NuLu
Review Overlay District
Report of the Urban Design Administrator to
the Committee

Case No: 16COA1182
Classification: Non-Expedited

Property Address: 700 E. Main Street, 121 S. Clay Street

Revisions to the elevations:

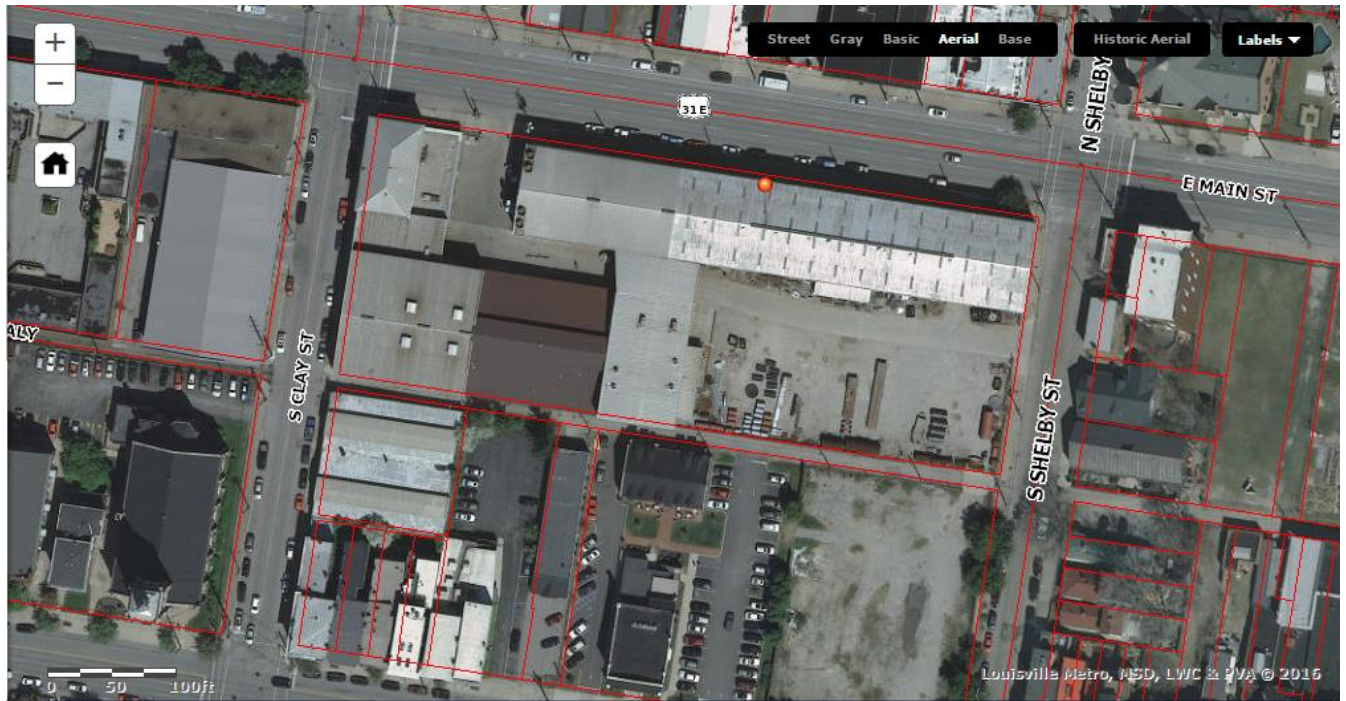
1. The full balconies along the south façade overlooking the adjacent properties have been replaced with "Juliette", or recessed, balconies (this is reflected in the revised elevations)
2. For better compliance with Guideline B6, the design of the Main Street building has been revised to better address floors 4 and 5 and a more enhanced cornice and material change has been included between floors 3 and 4
